Modification instructions for:

# XO-DAC

## Introduction

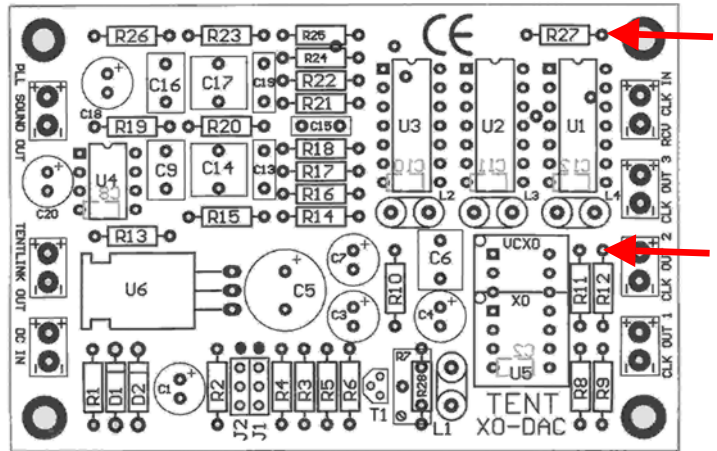
First generation XO DAC (PCB # PvV0238) does not include an easy adaptation to switch to TENT link mode. When XO DAC runs in master mode and XO3 runs in slave mode, i.e. when using TENT link, XO DAC needs below described adaptations.

- Lift R27 and R12 need to at the indicated positions (red arrows)
- Carefully stretch both remaining wires from both resistors
- Rotate R27 about 90 degrees clockwise, so it points downwards, more or less between U1 and U2
- Slightly shift the upper (lifted and stretched leg) of R12 to the right (1 mm)

Now prepare 2 pieces of wiring (2.5 and 3.5 cm), remove 1 mm of insulation at both sides, and prepare them by applying some solder at both sides

- Solder each wire to the remaining end of the resistors (2.5cm to R27, 3.5cm to R12)
- Put 1 cm of sleeve over each wire, fully covering the solder joints at both resistors
- Solder the remaining end of wire from R27 to the free soldering island where R12 used to be
- Solder the remaining end of wire from R12 to the free soldering island where R27 used to be
